Vogtle Project

NRC DOCKET NUMBERS 50-424 AND 50-425
CONSTRUCTION PERMIT NUMBERS CPPR-108 AND CPPR-109
VOGTLE ELECTRIC GENERATING PLANT - UNITS 1 AND 2
REQUESTS FOR ADDITIONAL INFORMATION: DSER OPEN ITEMS

OPEN ITEMS INDEX

Figure 406-1 Ultrasonic Instrument Calibration Record

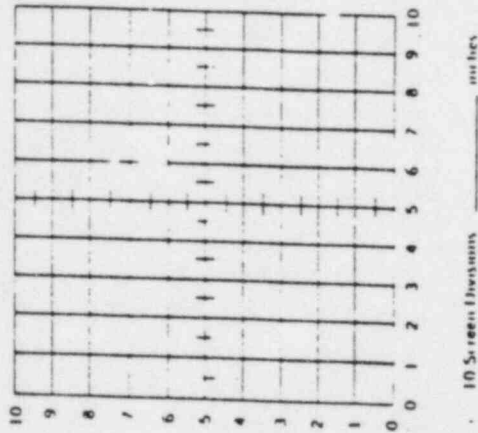
- 8.4 The temperature of the calibration block shall be within 25°F (14°C) of the component to be examined.
- 8.5 The equipment calibrations shall be performed in accordance with the following and the results documented on Ultrasonic Instrument Calibration Record, UT-H/F/V-Form 400D (Figure 406-1).

5. Connect the marks and extrapolate to cover the full examination thickness in order to establish the DAC curve. Record the amplitudes and sweep readings of each reflector on the Ultrasonic Instrument Calibration Record, Form 400D (Figure 406-1).
6. Obtain a signal from the ID notch and maximize the signal. Adjust the instrument gain control to set the notch amplitude to the level of the DAC curve. This is the Primary Reference Response. Record the amplitude and sweep reading of the notch on the Ultrasonic Instrument Calibration Record, Form 400D (Figure 406-1).

- 8.7.1 A calibration check on at least one of the basic reflectors in the basic calibration block or a check using a simulator or reference block (e.g., Rompas or DSC block) shall be made at the finish of each examination or every 12 hours of examination, and when examination personnel are changed. If a simulator or reference block is used, it shall be identified on the applicable calibration sheet (Figure 406-1).
